ADDENDUM NO. 1

September 14, 2026

**Perry Meridian High School Phase 2 Renovations
401 W. Meridian School Road
Indianapolis, IN 46217**

MECHANICAL HVAC PLAN NOTES

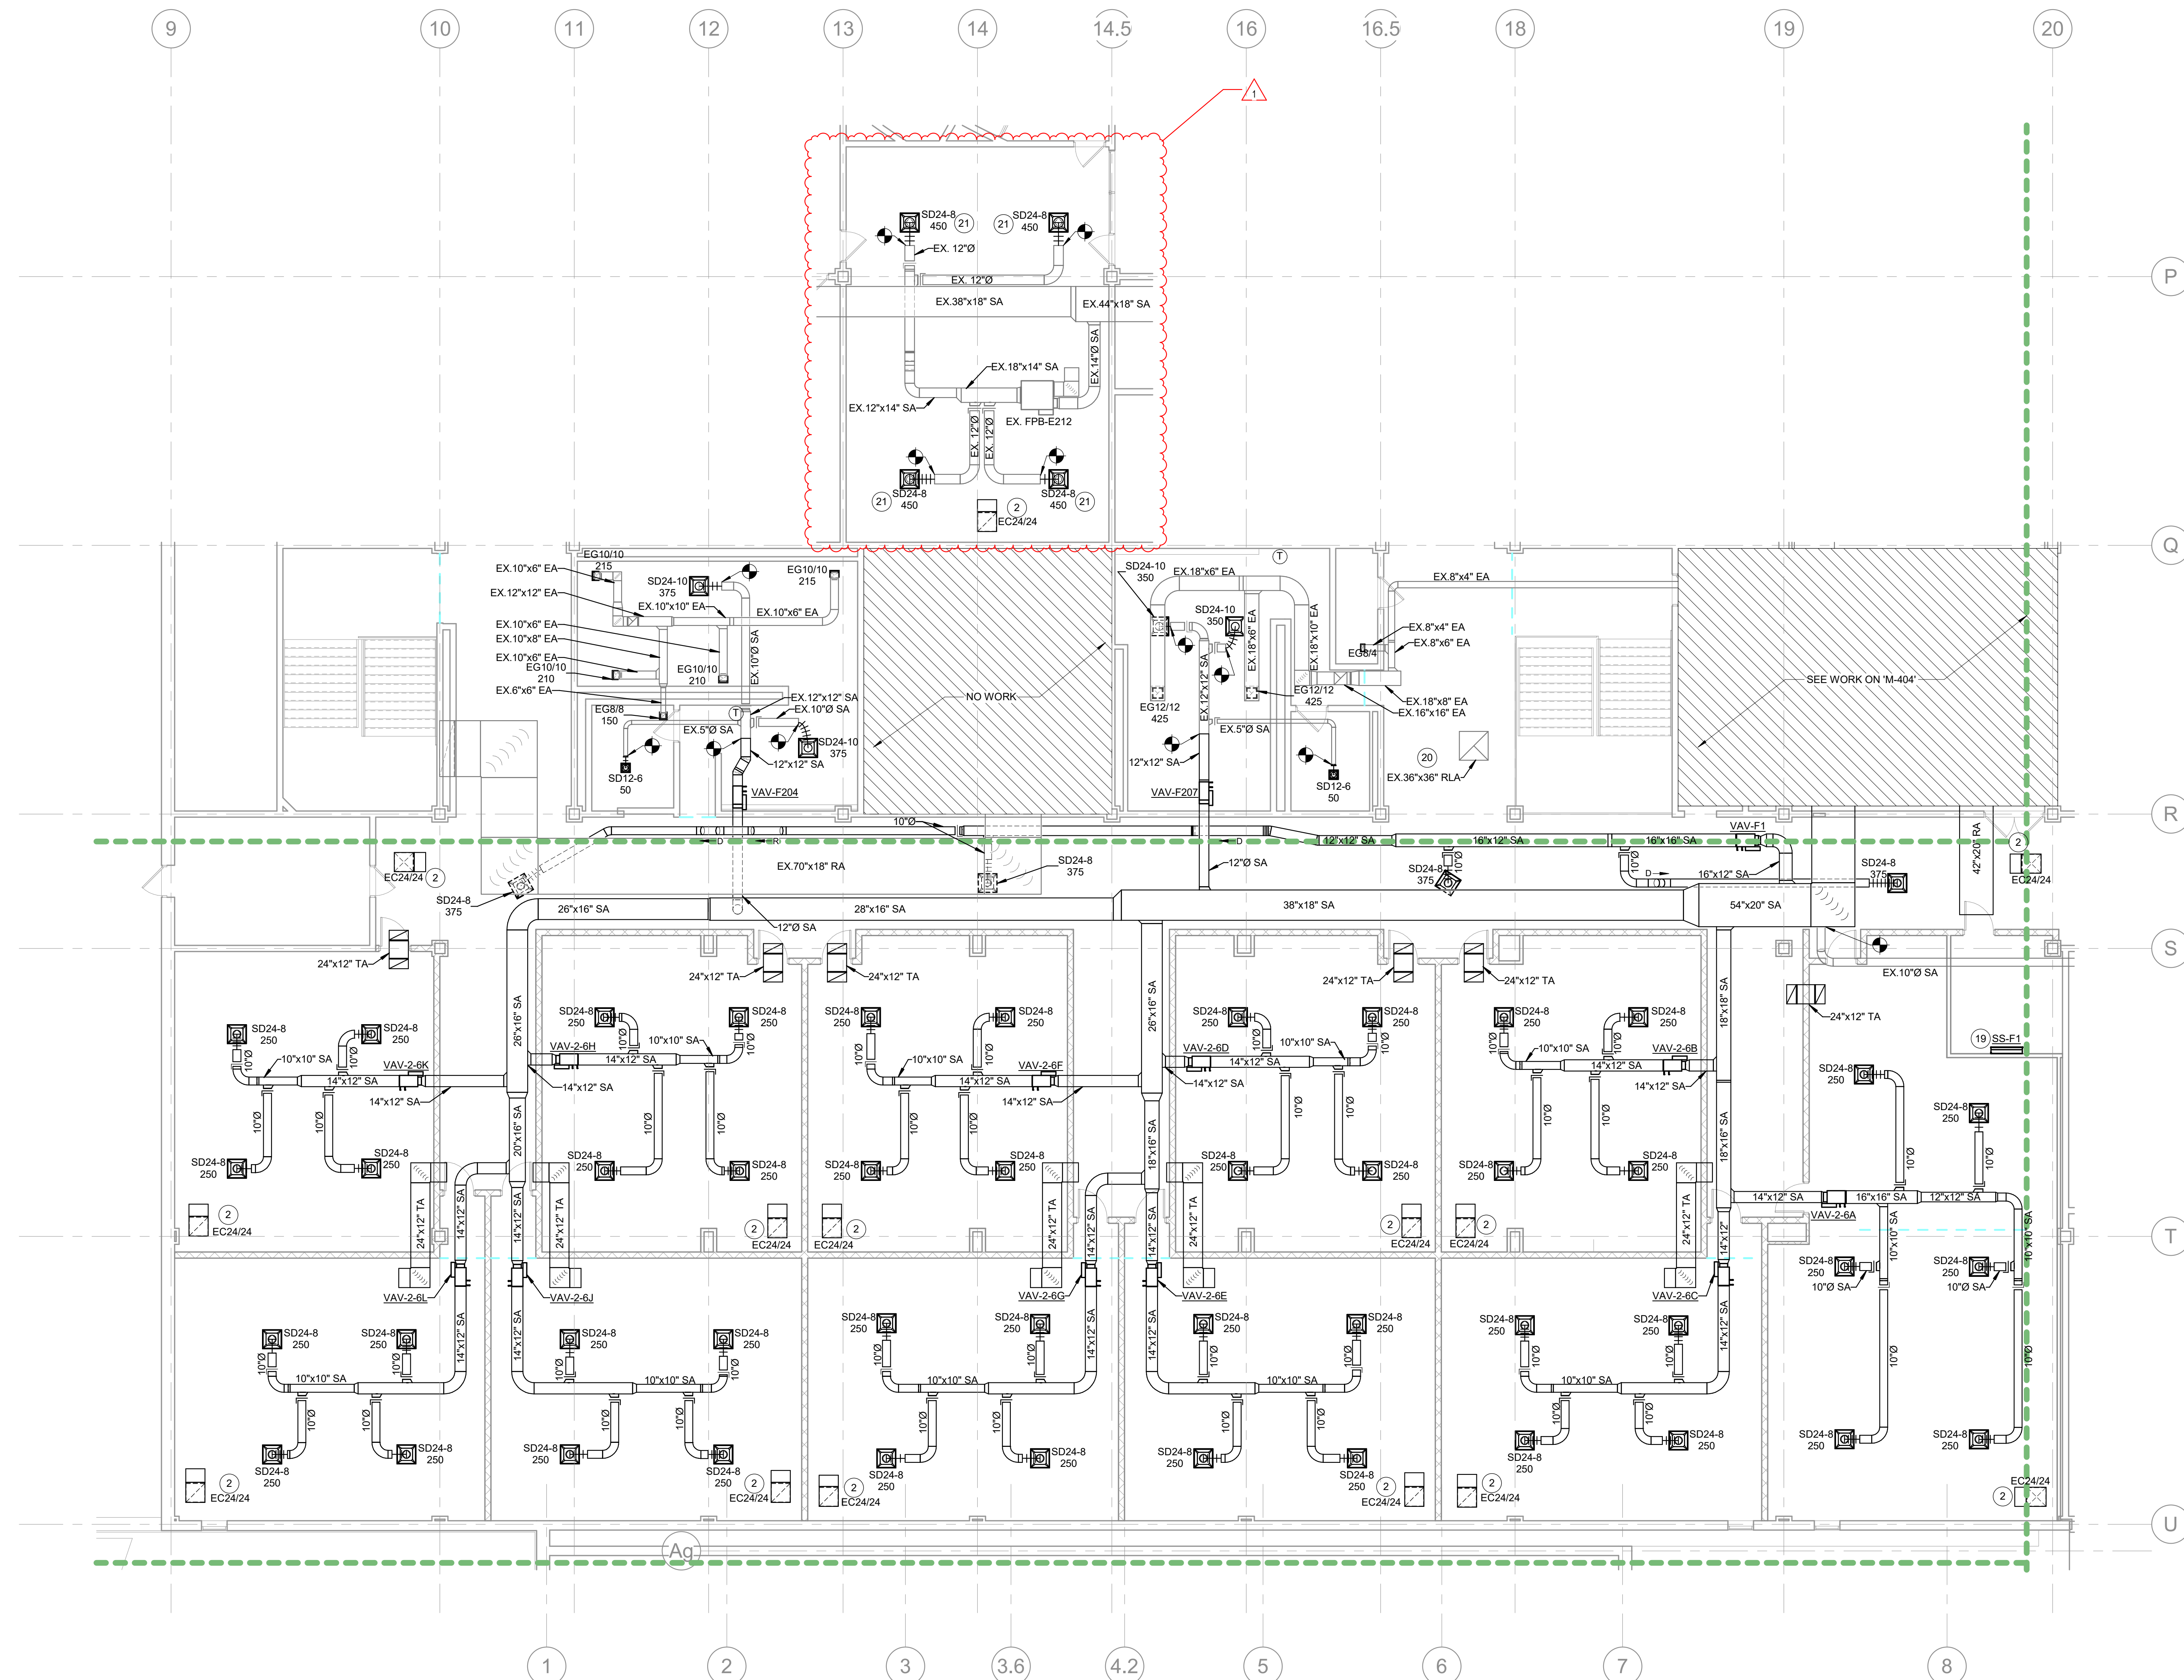
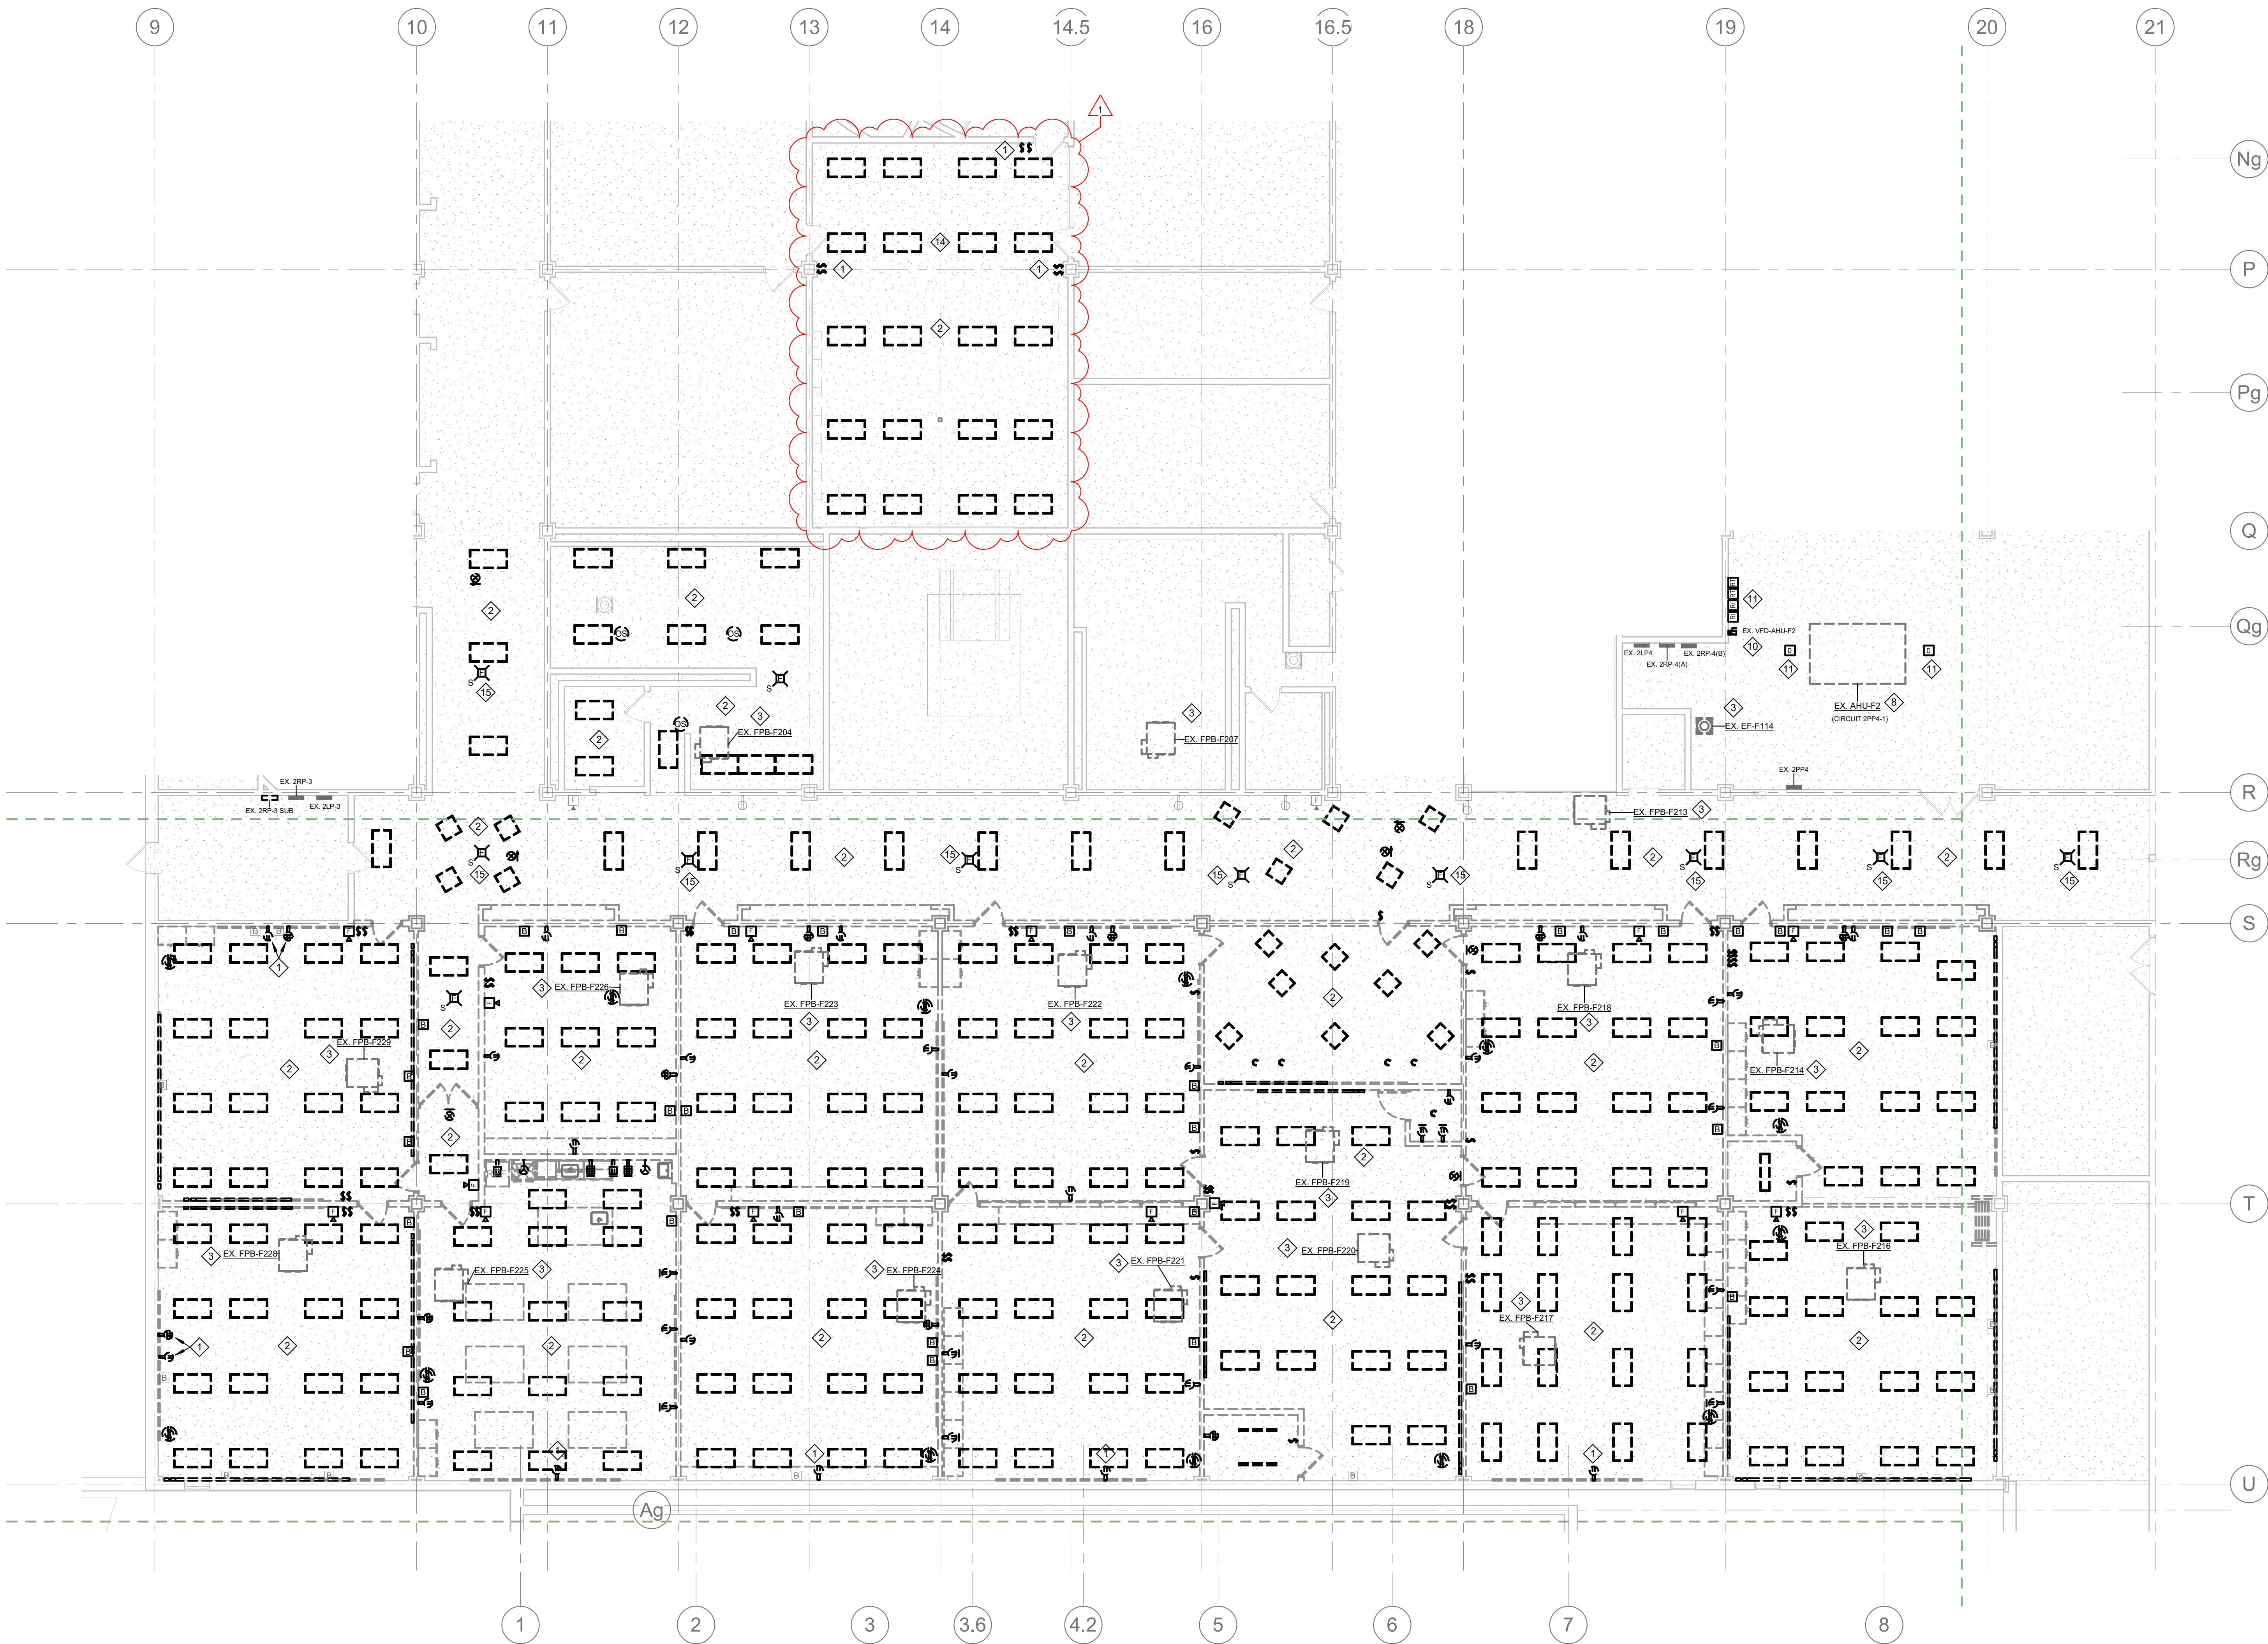
Change: Revise sheet to include scope of work to install ceiling supply diffusers and return grilles in new ceiling in BUSINESS 2-8C.

1. Revise sheet to include scope of work to install ceiling supply diffusers and return grilles in new ceiling in BUSINESS 2-8C.

1 ELECTRICAL LIGHTING FIRST FLOOR PLAN - UNIT H
1/8" = 1'-0"

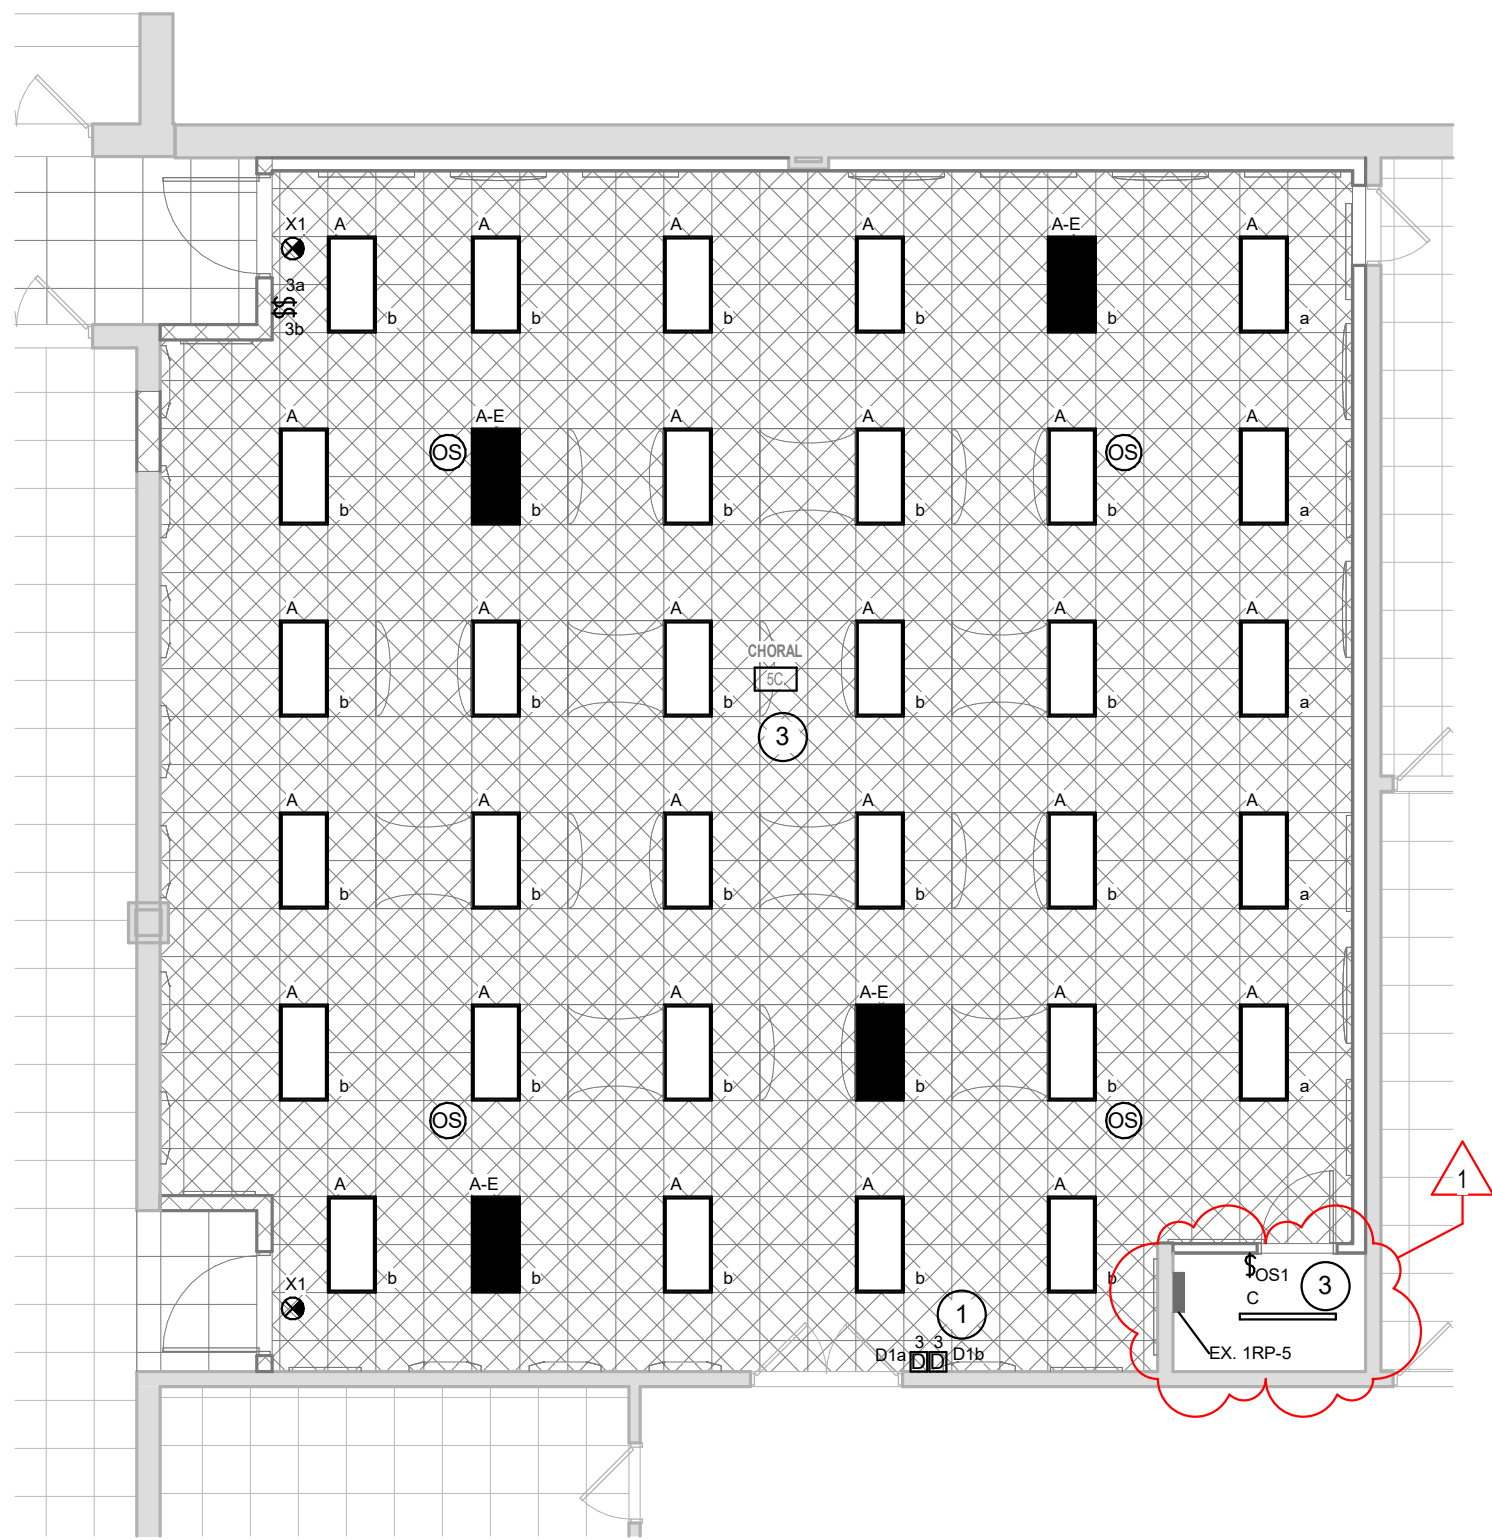
Change: Revise sheet to change light fixture type to match ceiling condition in closet of CHORAL 5C.

1. Revise sheet to change light fixture type to match ceiling condition in closet of CHORAL 5C.
